THERMAL REDUCTION CO., INC.
TEMPORARY ASH STORAGE FACILITY

TEMPORARY ASH STORAGE FACILITY
NEW SITE PLAN

TEMPORARY ASH STORAGE FACILITY
PIPING & ELECTRICAL PLAN

DRAWING **G3**
 SHEET 3 OF 13

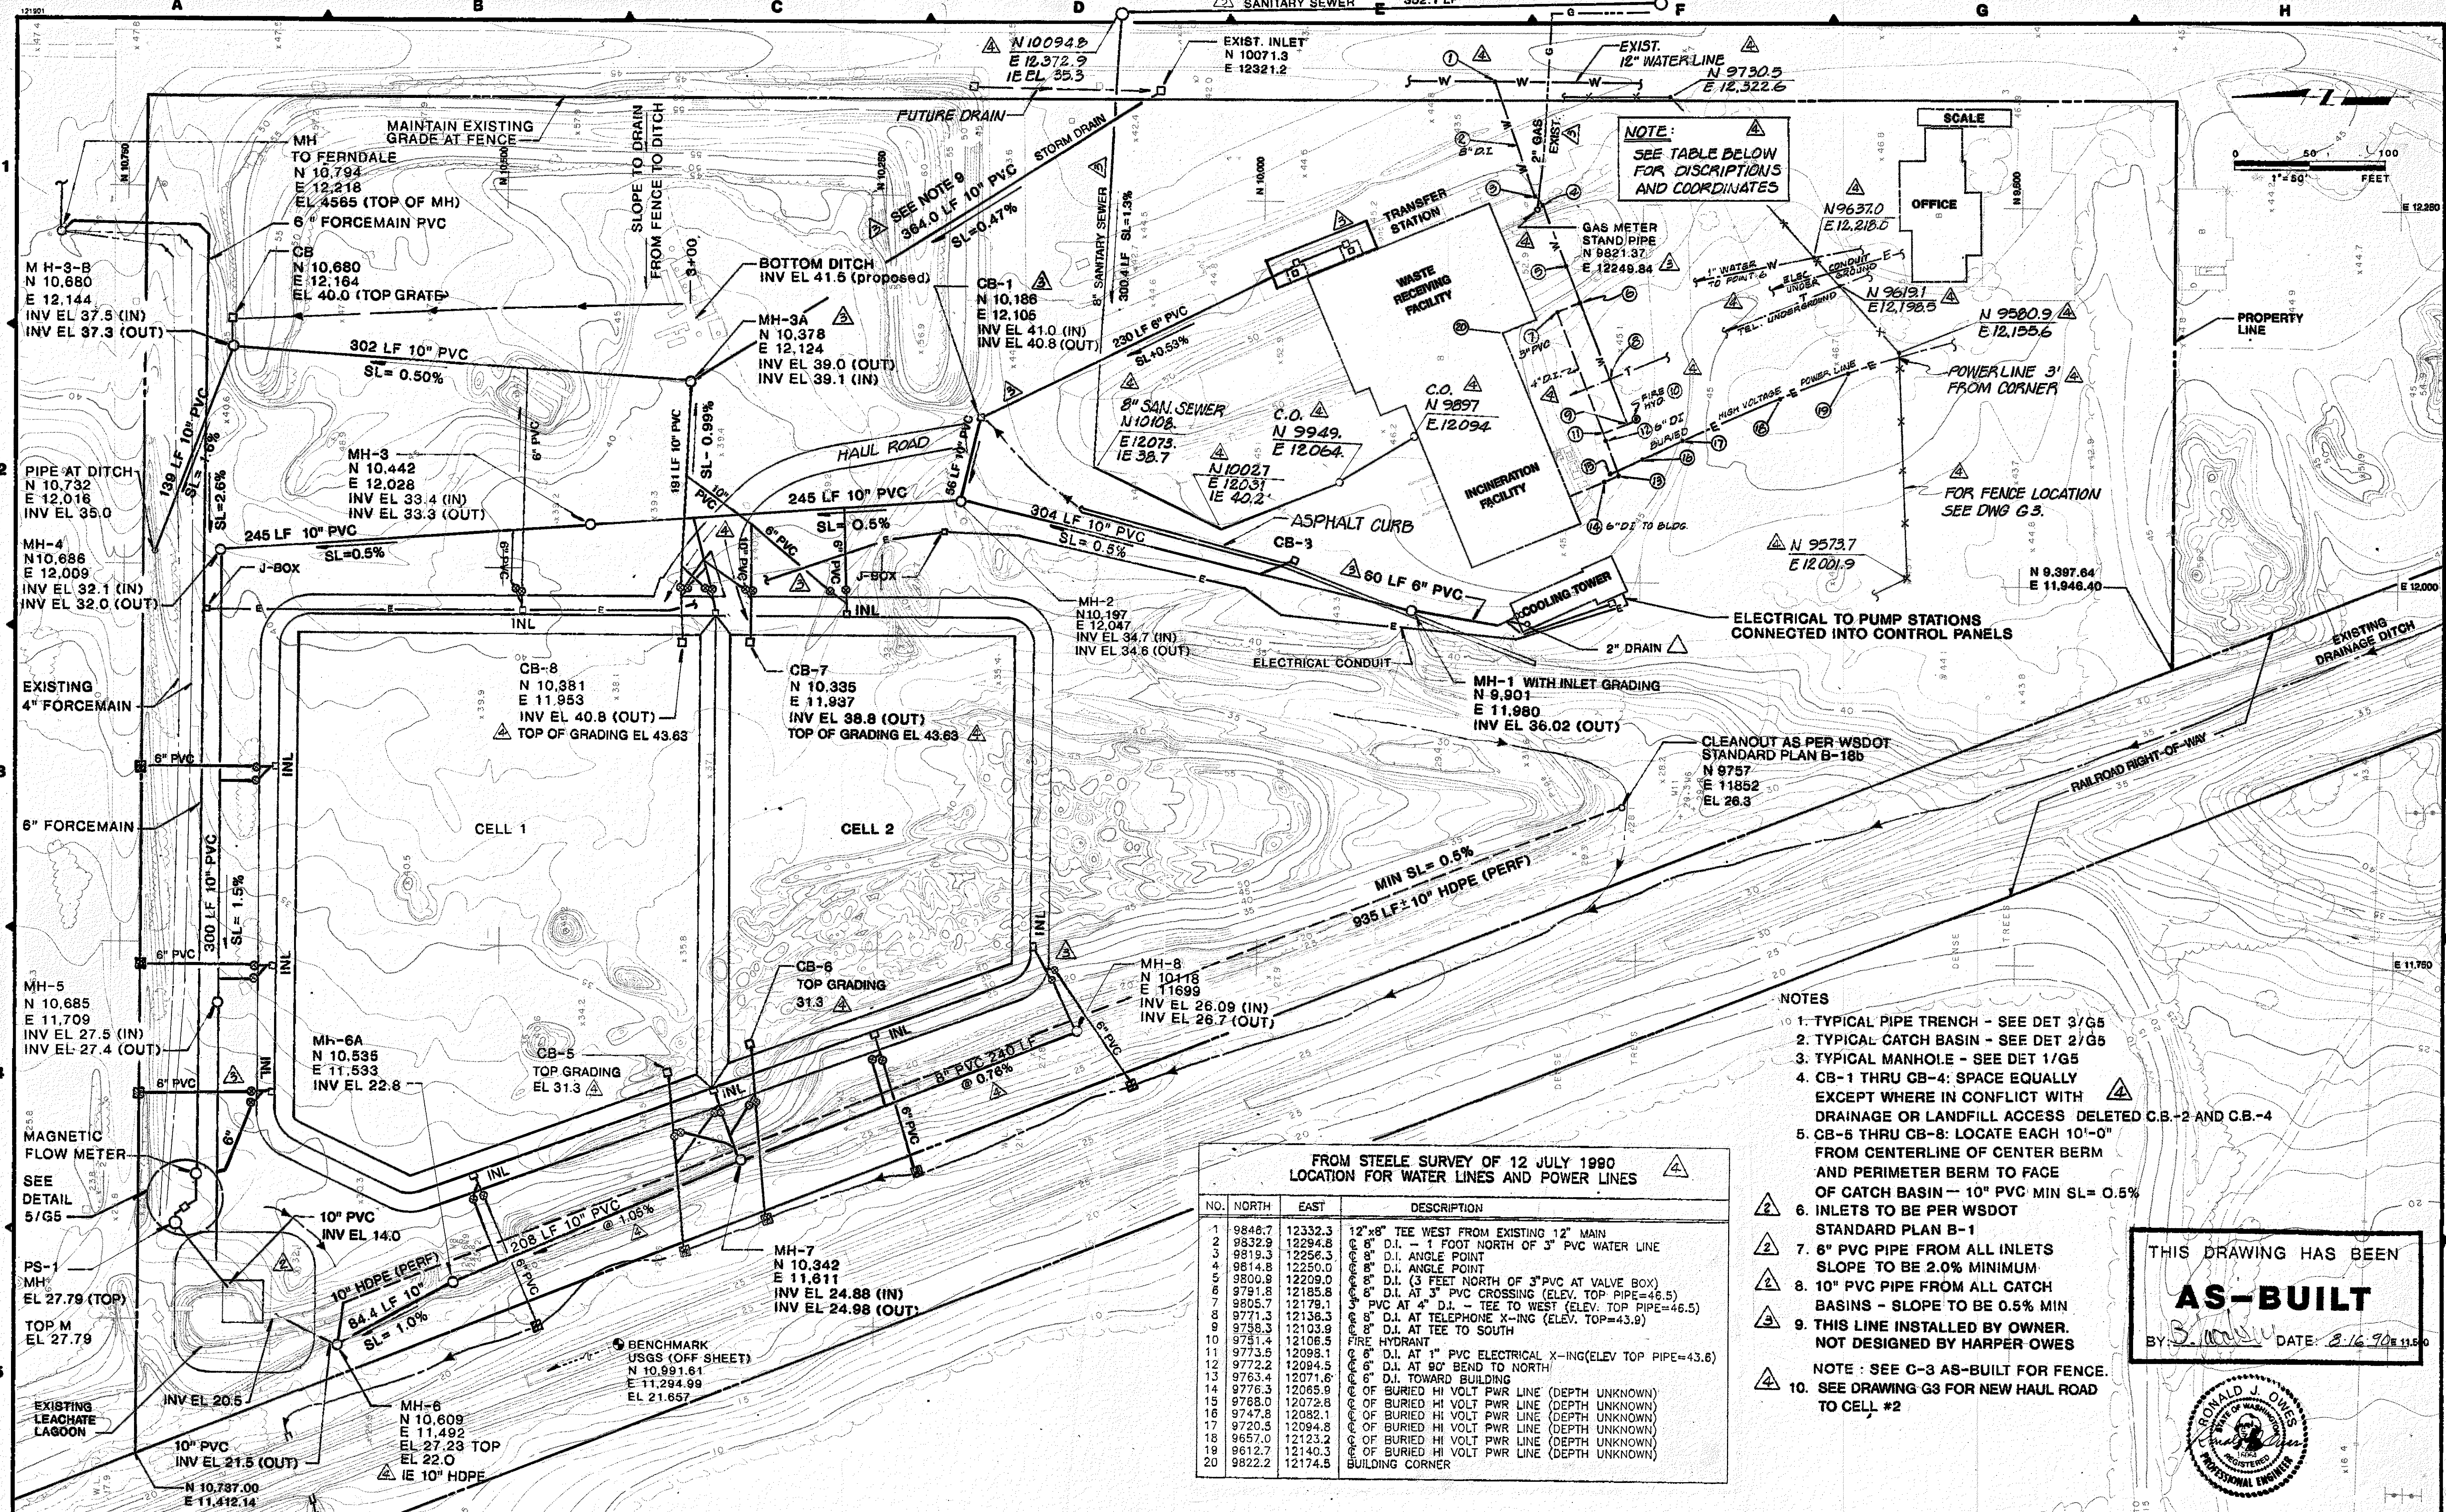
THIS DRAWING HAS BEEN
AS-BUILT
 BY: *B. [Signature]* DATE: 2/16/90

AS-BUILT PER H. RADER	NK	03-90
AS-BUILT PER H. RADER	NK	5-23-90
AS-BUILT	PS	11-24-89
NO. REVISION	BY	DATE
